EAST PORTAL
STABILITY STUDY

CARLIN CANYON TUNNELS

ELKO CO. NEV.

CONTRACT 1441

FIGURE NO. 1

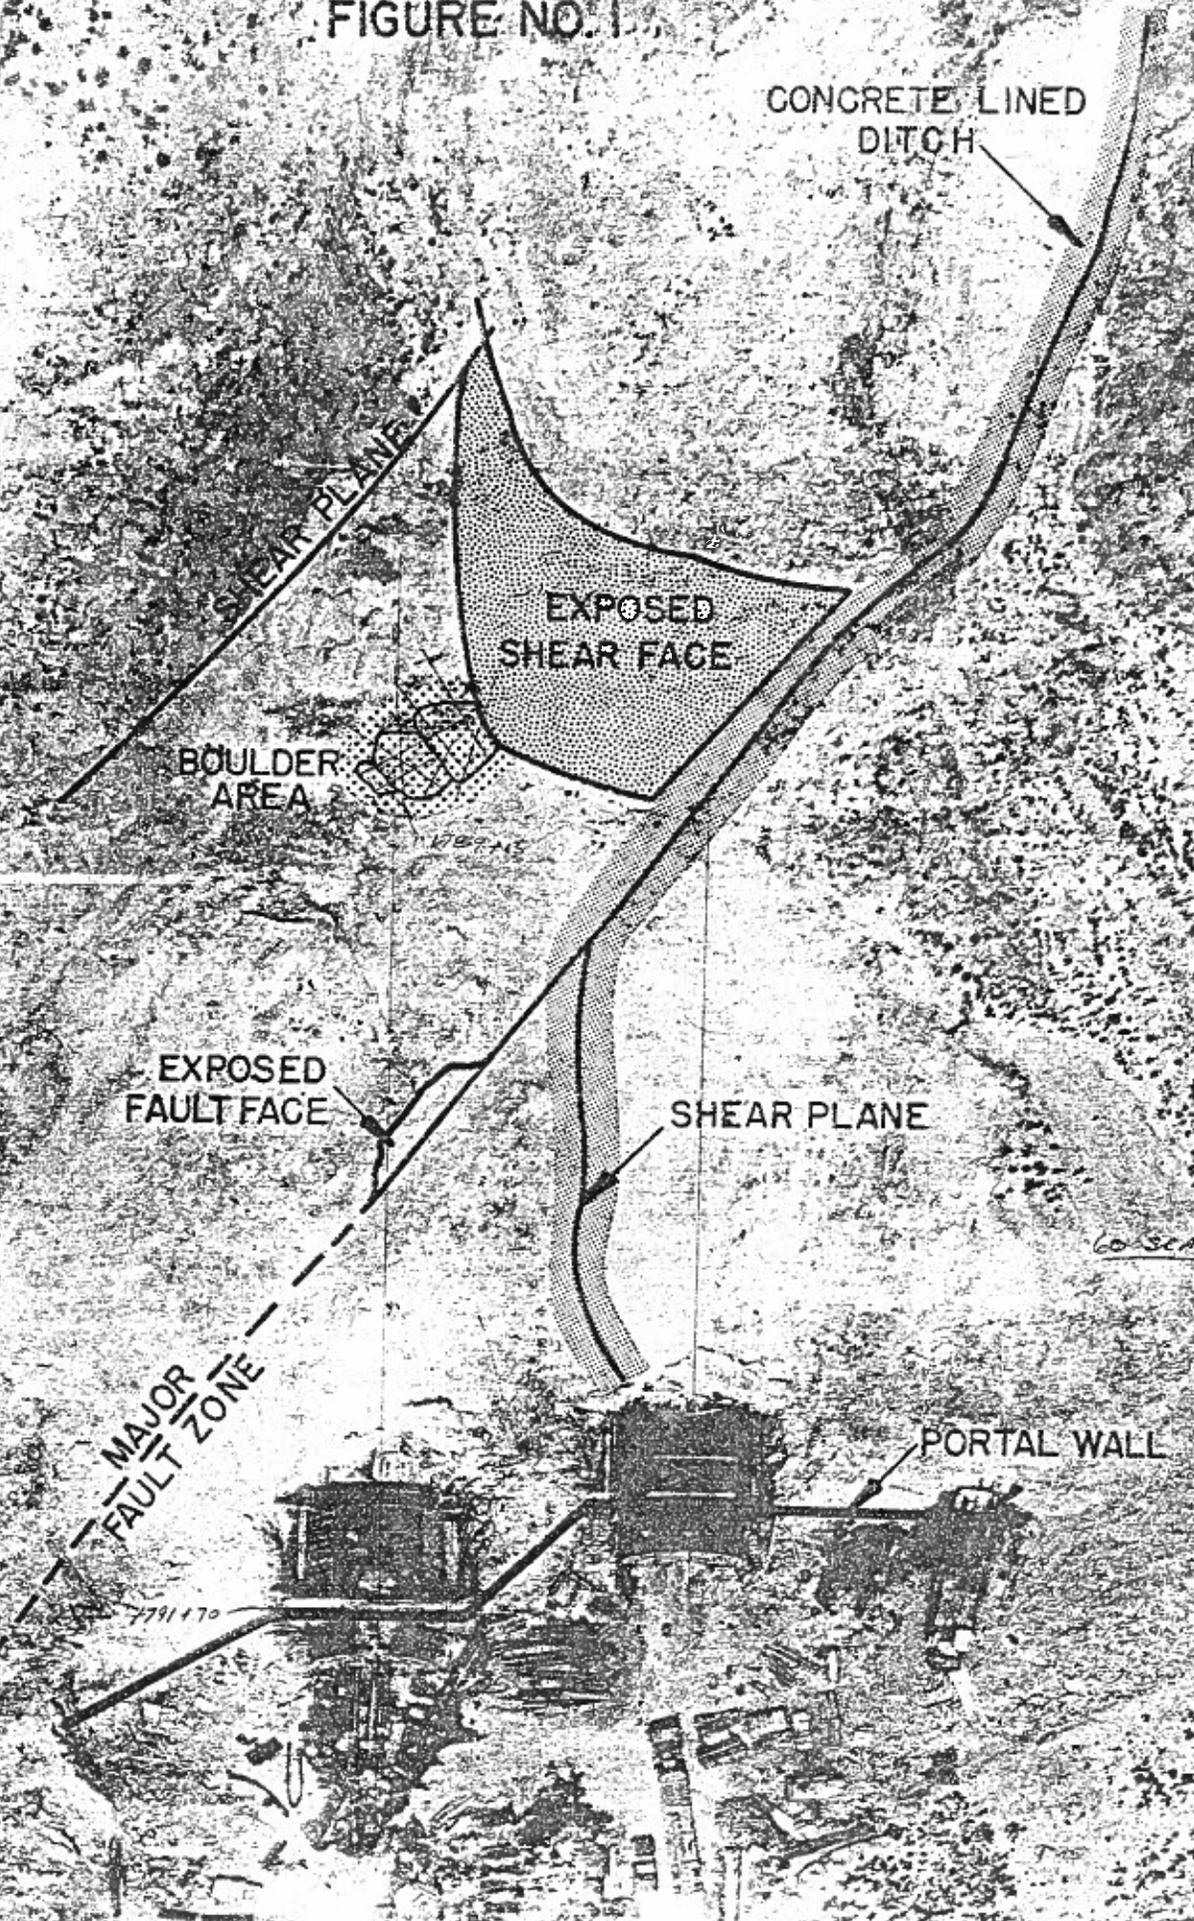
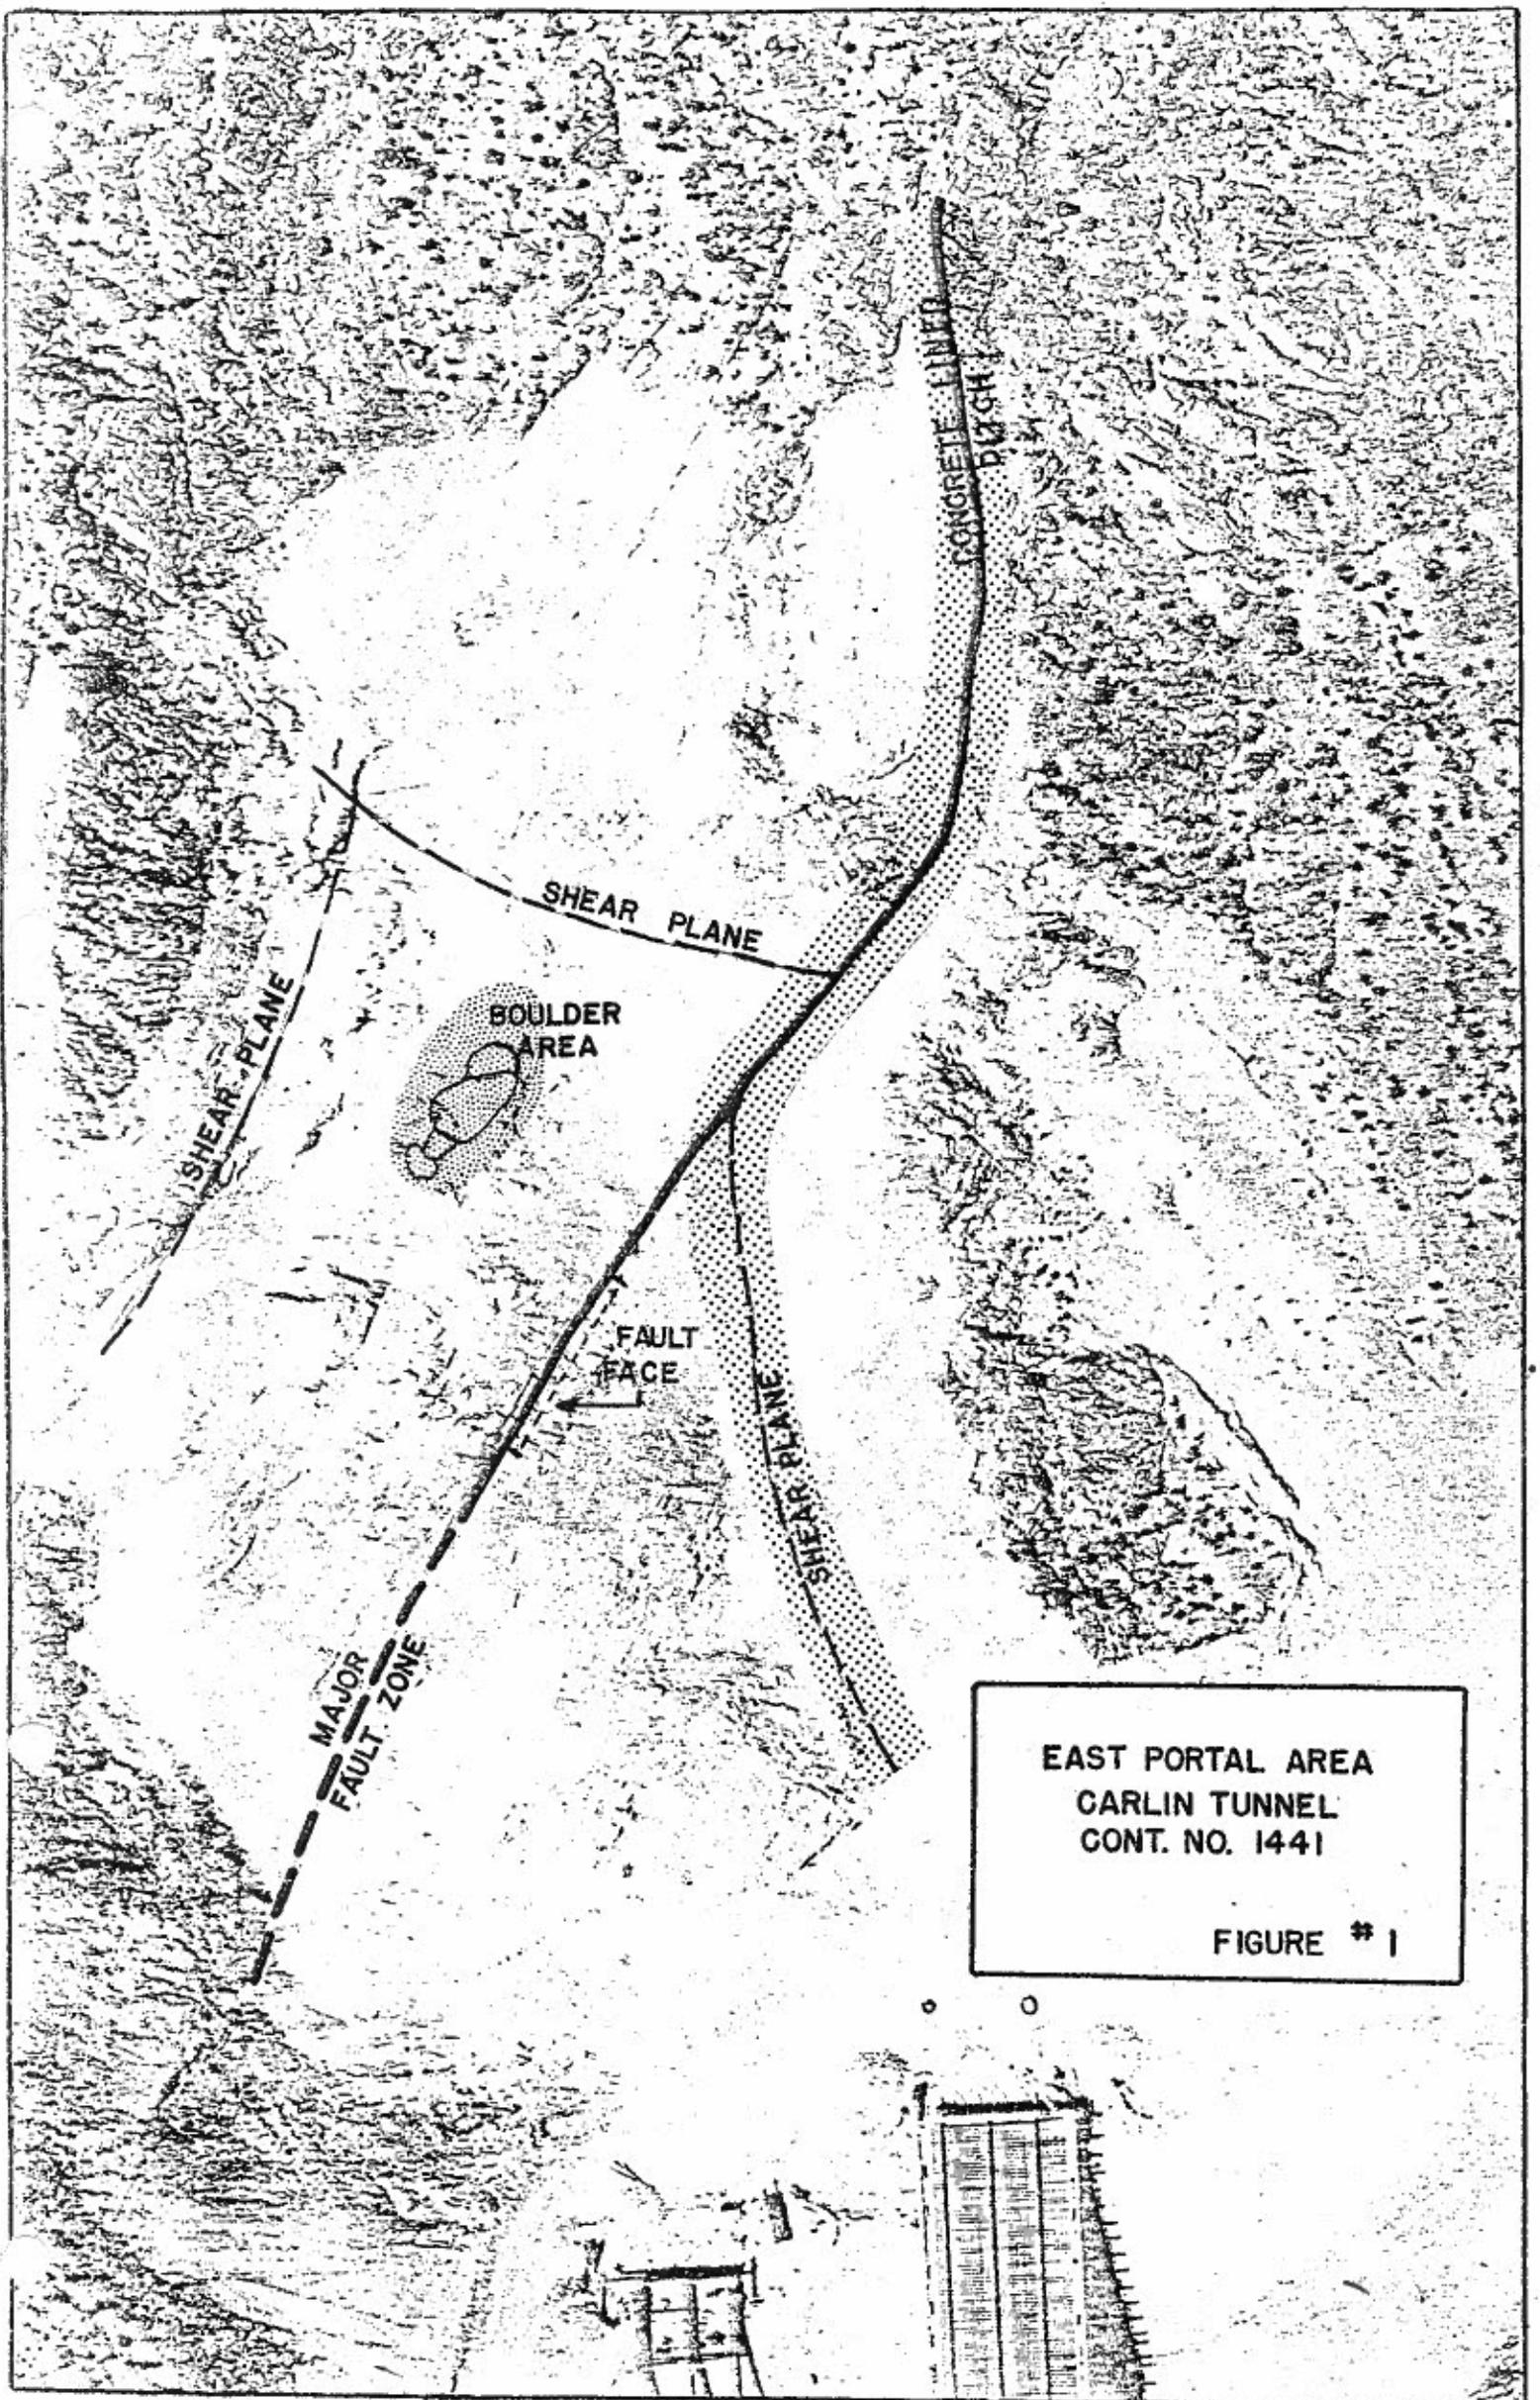
The major fault trends N 15° - 20° W and dips 70° - 80° NE. This is apparently a bedding plane fault with dip and strike correlating quite closely to the dip and strike of the bedrock. Another smaller, steeply dipping shear zone, in some places less than 1/2" wide crosses the major fault approximately 100' west of the westbound centerline. About 140' behind the portal wall and approximately equidistant between the two bores, this plane intersects another shear zone along the bedding plane. The intersection of these three planes has produced a triangular area of potentially unstable material consisting of large "boulders" surrounded by highly sheared although essentially competent material. (See Figure 1.)

4.5. Drainage above the portals should be such that no ponding can take place, and if any vertical fractures are discovered they should be filled with grout. Since the major fault zone is depressed in the upper area and acts as a drainage channel, as an extra precautionary measure to prevent water from entering this zone the depression could be cleaned and lined with concrete. (See Figure 1).
